Delegated Report

Planning Application No: 20220619

Location: 15 Harden Road Northfleet Gravesend Kent

Description: Erection of a single storey 1 bedroom dwelling in the rear garden.

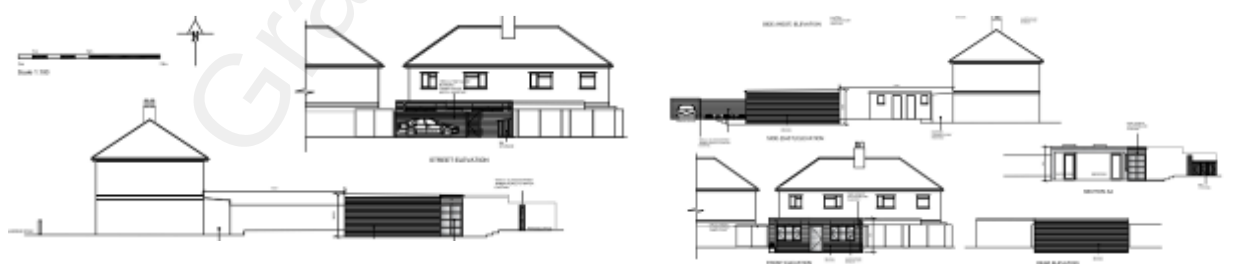
The proposal seeks the erection of a single storey 1 bedroom dwelling in the rear garden of 15 Harden Road.

The dwelling will span 8.2m and will be set within the boundaries and have a minimum depth of 6.7 and a maximum depth of 8.3m owing to its L Shaped design. The dwelling will be finished with a flat roof which will have an overall height of 3m and include 3 roof lights which will serve a bathroom and a kitchen/diner/living area.

The internal layout comprises a kitchen/diner/living area, one bedroom, a bathroom, and a store cupboard. The site frontage provides a single parking space and a garden for the proposed dwelling which is set behind a 1.8m high close boarded fence to match the existing fencing at the site.

The proposed dwelling is set back from the Henry Gardens frontage within the rear garden of the application dwelling. The proposed dwelling has a front garden space for use as amenity space which is not ideal. The scale and appearance of the proposed dwelling fails to respect the surrounding buildings. The width of the dwelling introduces a prominent and visually intrusive building into the rear garden area which will dominate the outlook from neighbouring properties and reduce their amenity. Furthermore the dwelling will be finished with a flat roof which is not encouraged nor supported by the Council. As such the proposal will not integrate well into the surrounding area, contrary to Core Strategy Policy CS19 (development and Design Principles)

External space standards (proposed dwelling)

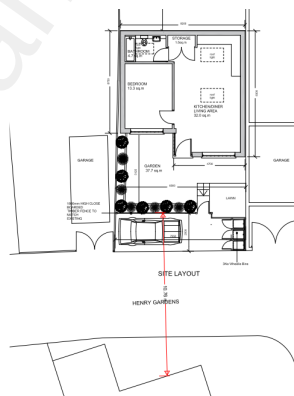
The Residential Layout Standards set out minimum space standards for private garden areas, requiring a minimum garden depth of 7.6m and garden area of 37.2m² for one bedroom dwellings. This is considered sufficient to provide adequate space for outside storage, clothes drying facilities and for leisure and play space. In this case (excluding the path to the front door and parking area as indicated in the Guidelines), the garden has a depth of 5.3m and a useable private garden area of 25m² which falls well below the minimum standard. Such an area would provide very limited play and leisure space and space for drying clothes for future occupants.
